# UNITED STATES PATENT AND TRADEMARK OFFICE

10/596,271

<b>Office Action Summary</b>	<b>Application No.</b> 10/596,271	<b>Applicant(s)</b> FEGER ET AL.	
	<b>Examiner</b> Fannie Kee	<b>Art Unit</b> 3679

## **DETAILED ACTION**

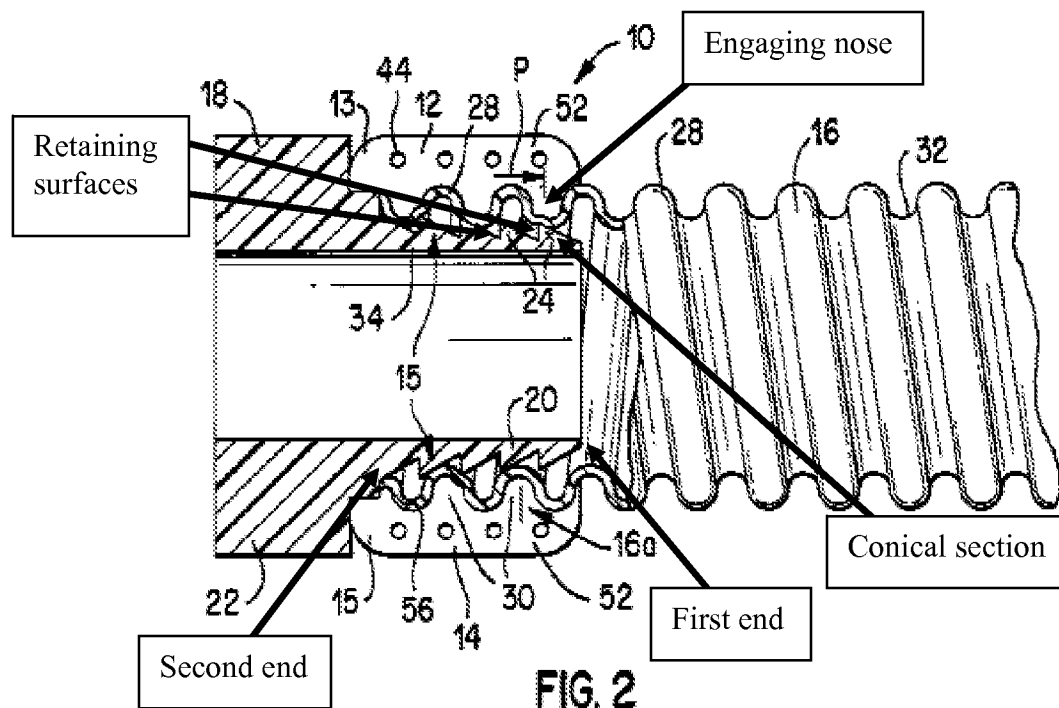
With regard to claim 7, and as seen in Figure 2 below, Merrett discloses a connector for connecting to the end of a corrugated conduit, said corrugated conduit including a plurality of elevated corrugations, said connector comprising:

an elongated connector portion (15) adapted for insertion into a said end of a said corrugated conduit, said connector having a longitudinal axis, said connector portion having first and second ends, said connector portion having a conical section located proximate said first end, said conical section including a ramp surface (24) which slopes radially outwardly in the direction of said second end;

a clamp (12, 14) spaced radially from said first end, said clamp including an engaging nose which is adapted to move into a clamping position wherein said nose fits between two of said elevated corrugations to thereby prevent said conduit from being separated from said conduit.

With regard to claim 8, and as seen in Figure 2 above, Merrett discloses said connector portion further including a radially outwardly extending retaining surface adjacent said ramp surface, said retaining surface facing said second end and being directed at a greater angle relative to said longitudinal axis of said connector portion than said ramp surface.

With regard to claim 9, and as seen in Figure 2 above, Merrett discloses two ramp surfaces (24, 24) and two retaining surfaces.

With regard to claim 11, and as seen in Figure 2 above, Merrett discloses said clamp comprising two clamping brackets (12, 14) disposed parallel to said longitudinal axis on

respective opposite sides of said connector portion, one of said brackets including said engaging nose.
